UNITED STATES
NUCLEAR REGULATORY COMMISSION
REGION III
799 ROOSEVELT ROAD
GLEN ELLYN, ILLINOIS 60137

Reports No. 50-329/82-07(DETP); 50-330/82-07(DETP)

Facility Name: Midland Plant, Units 1 and 2

REPORT ON CABLE INSTALLATION
MIDLAND PLANT UNITS 1 AND 2

SK#1

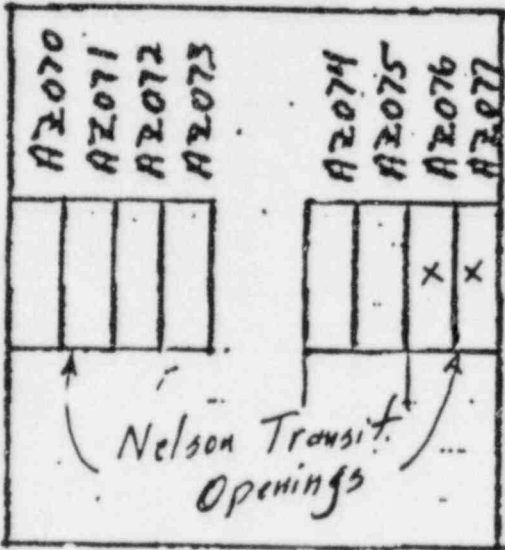
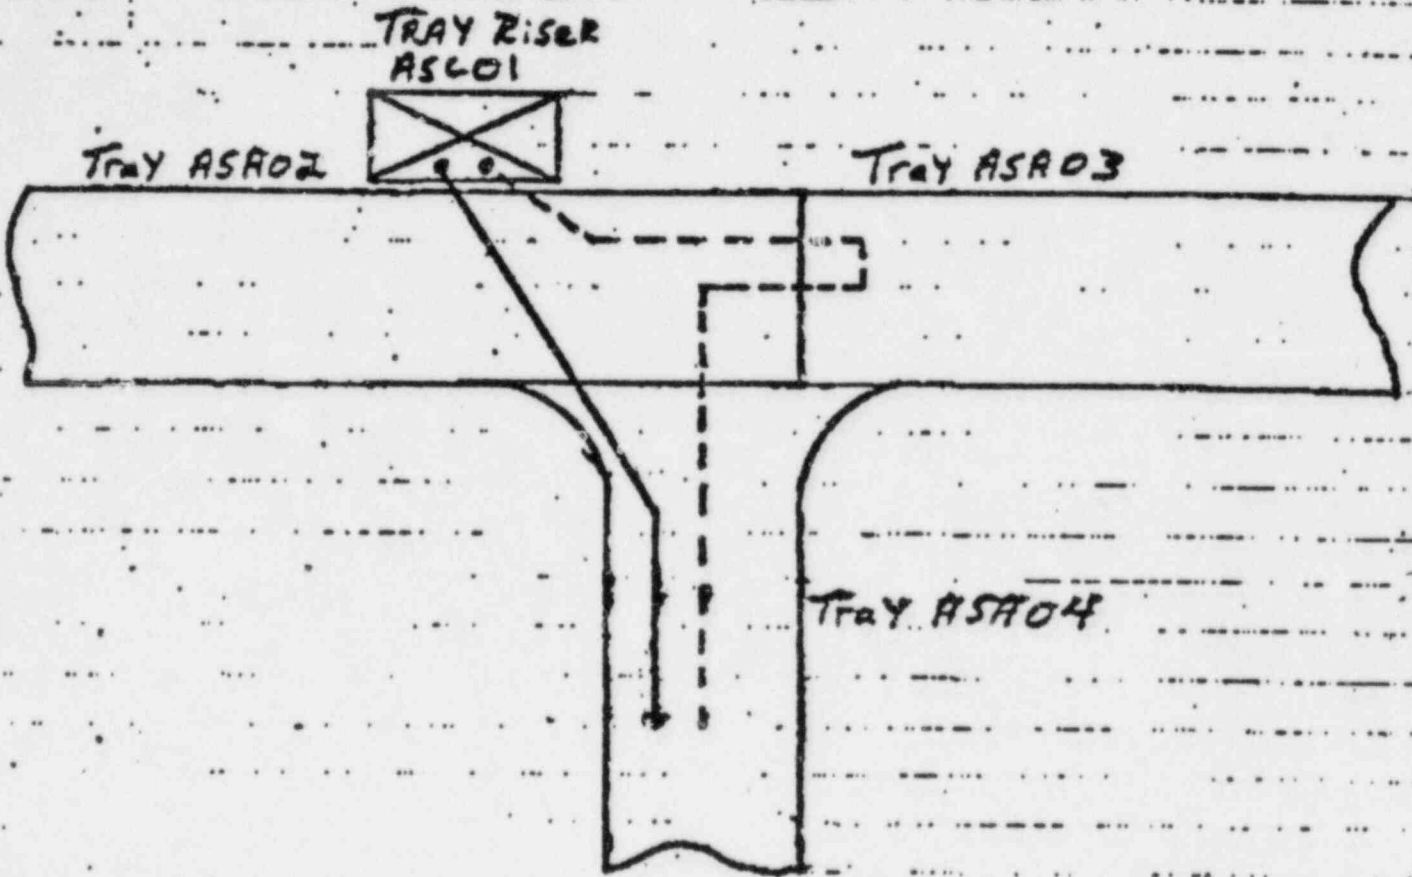
This cable was passed through the wrong Nelson transit (cable seal) window. Both the right and wrong window were for power cables. However, because of the closeness of power and instrument penetrations in the plant, our basic concern was a possible voltage violation if this problem were repeated with a power cable being passed through an instrument cable window.

Quality control will inspect all cable transitions from one raceway to another; this inspection will eliminate this concern.

SK-3

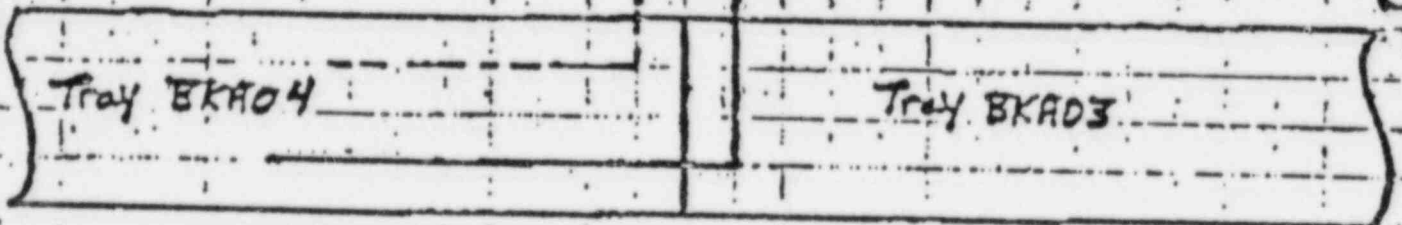
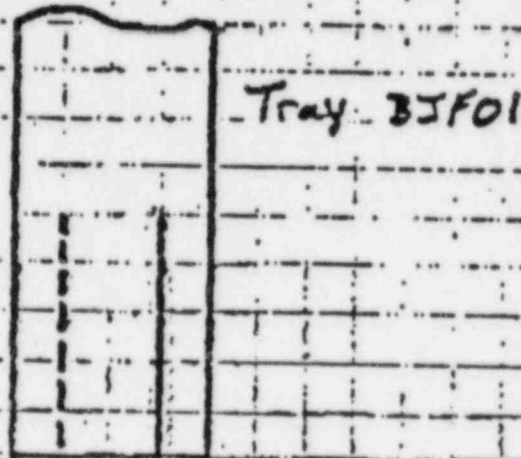
The subject cable enters the confines of an additional raceway. If the trays containing subject cable were required to be wrapped, how do we make sure that the cable portion in the unlisted via is protected.

SK-4

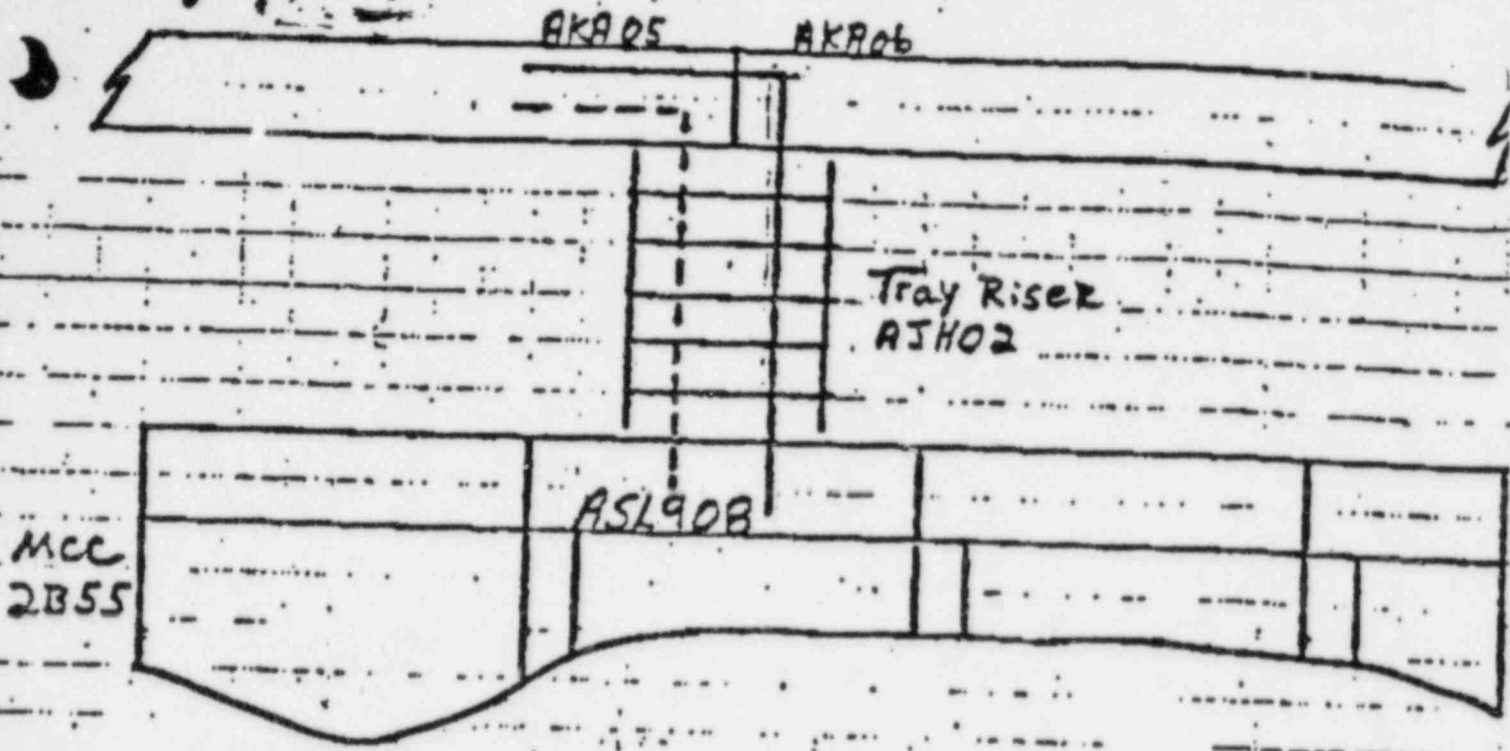
The subject cable enters the confines of an additional raceway. If the trays containing subject cable were required to be wrapped, how do we make sure that the cable is protected.

SK-8

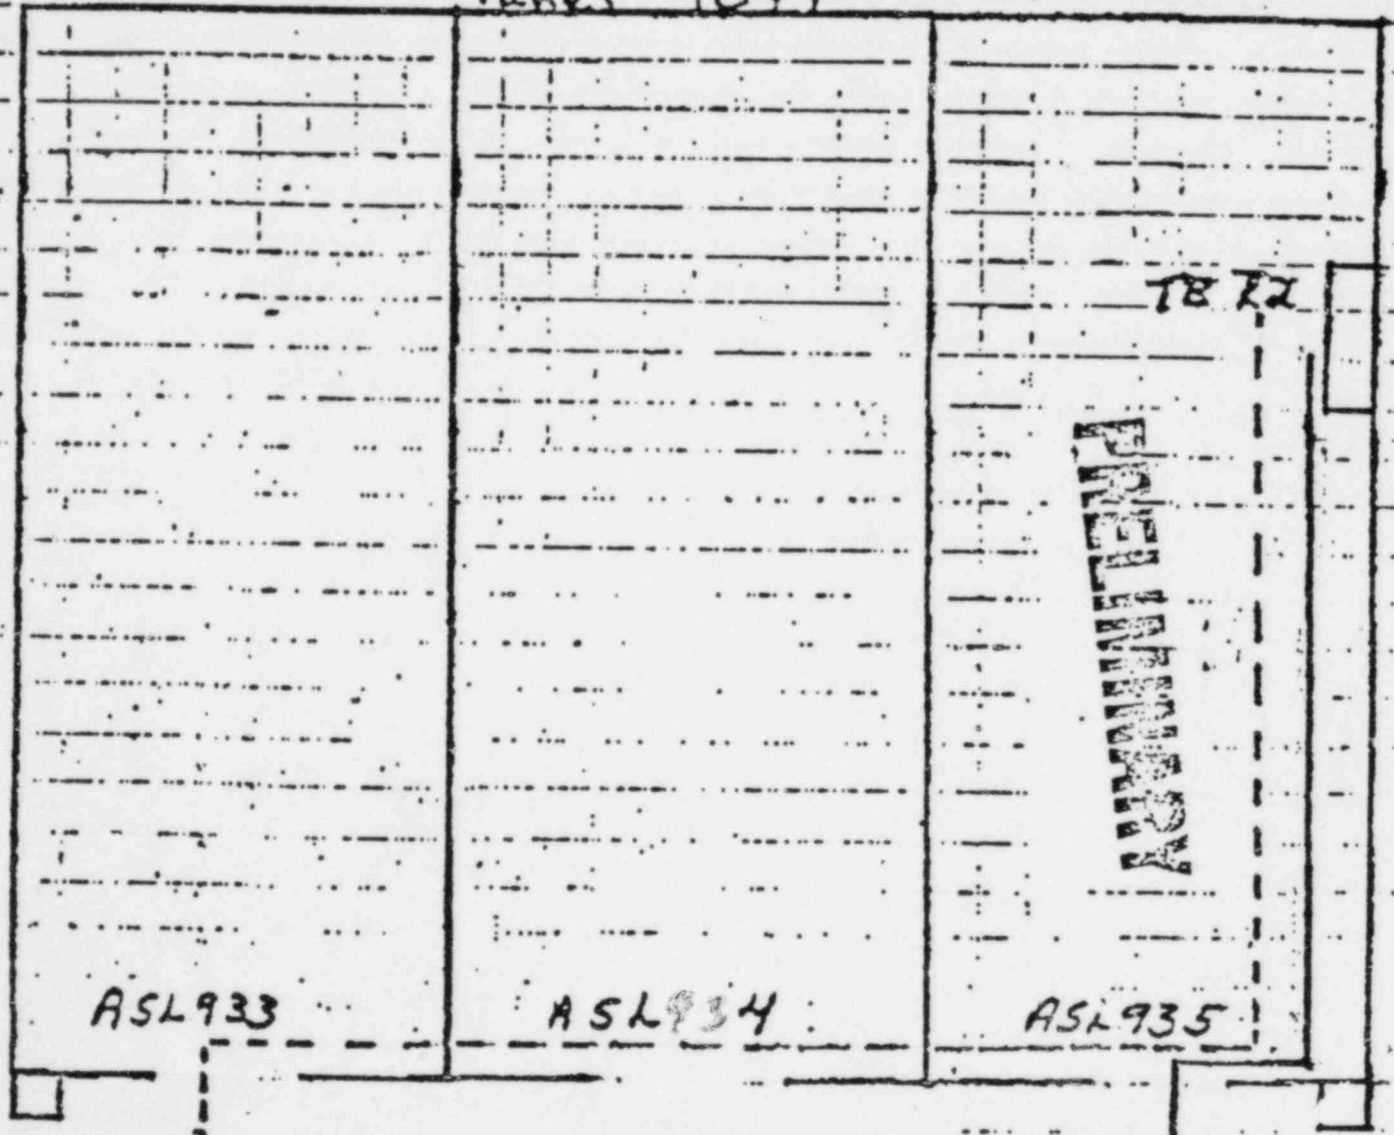
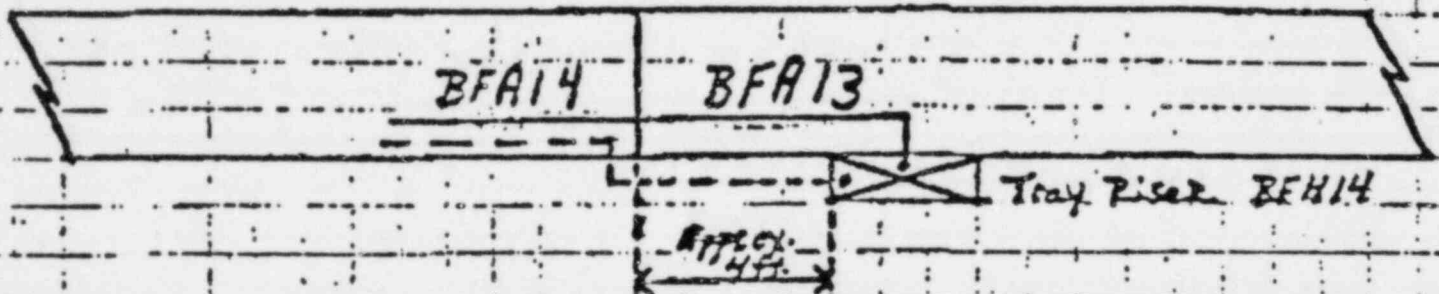
Cable was routed to the wrong compartment of the control panel. Field discovered E37 error then pulled and terminated cable at the correct compartment. E37 did not reflect as-built condition.

SK-10

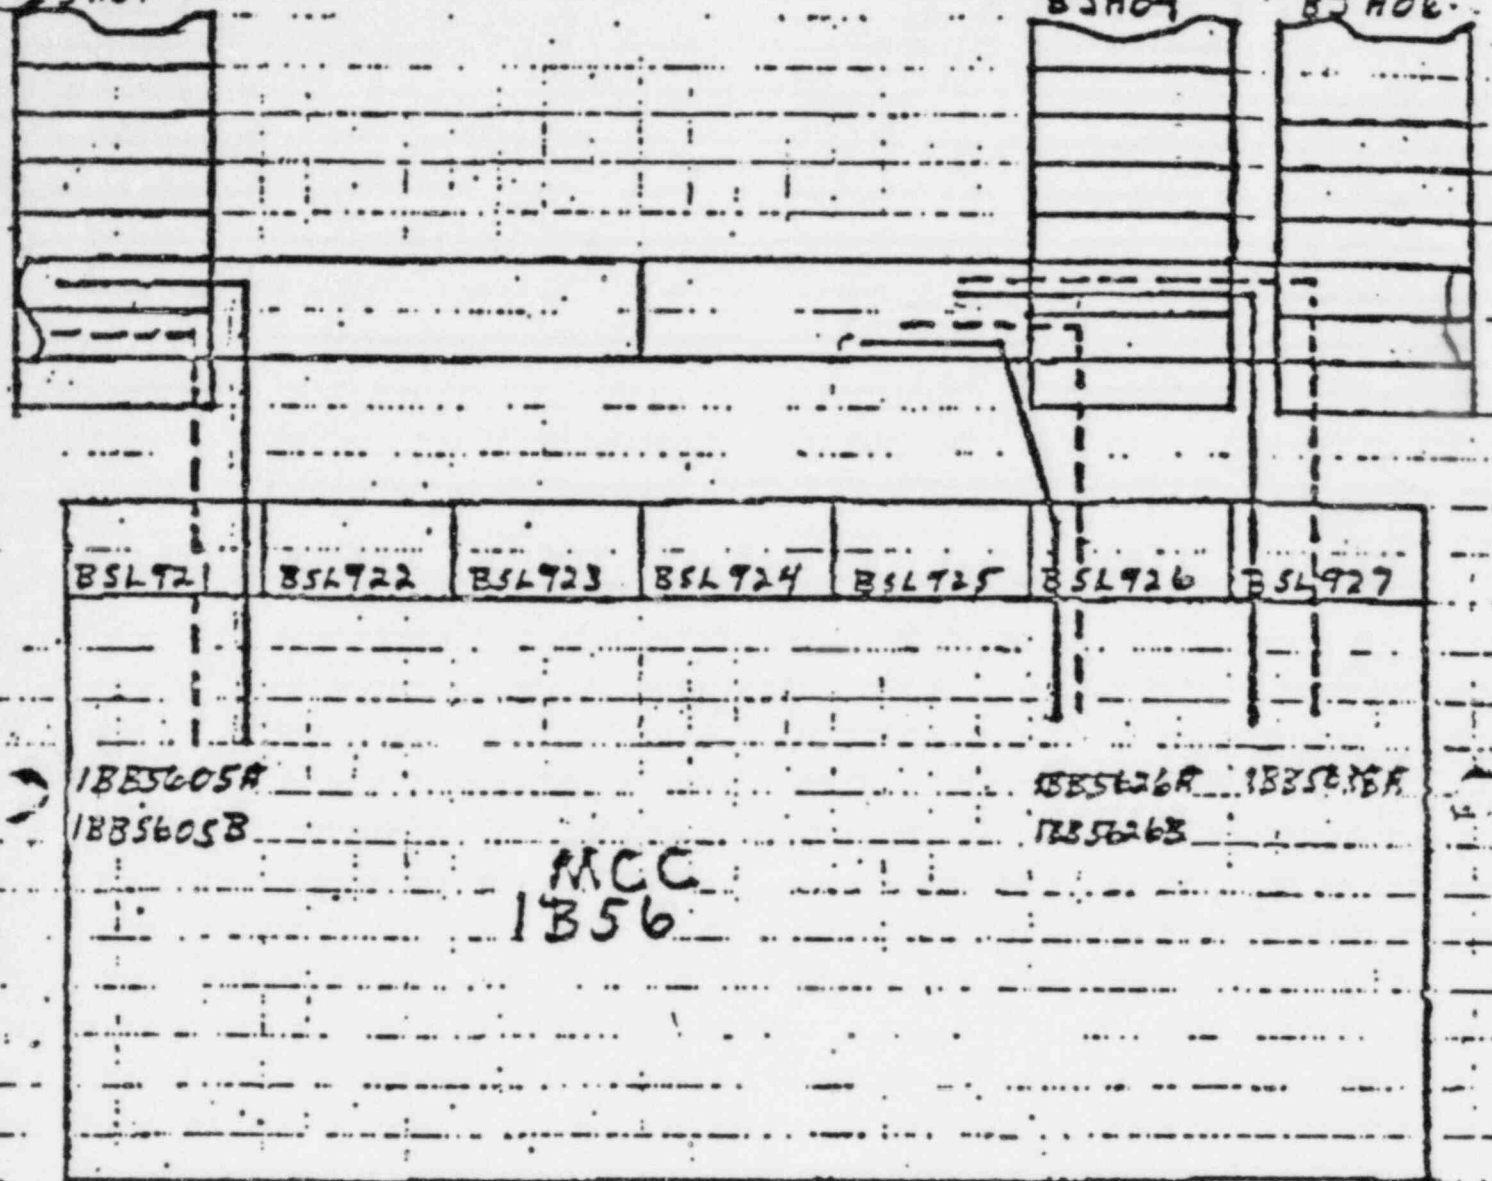
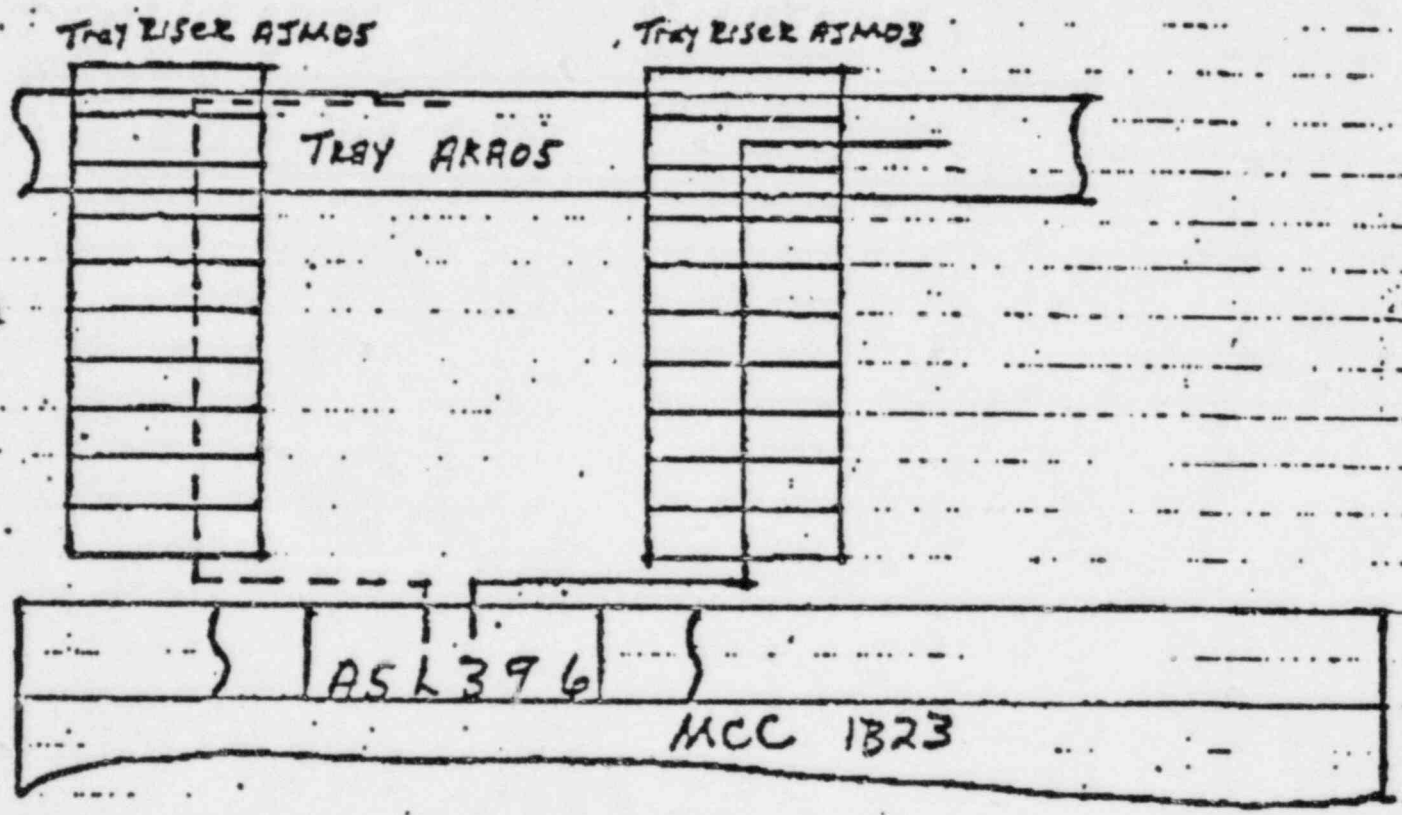
Cables are airlined, and are not in the riser.
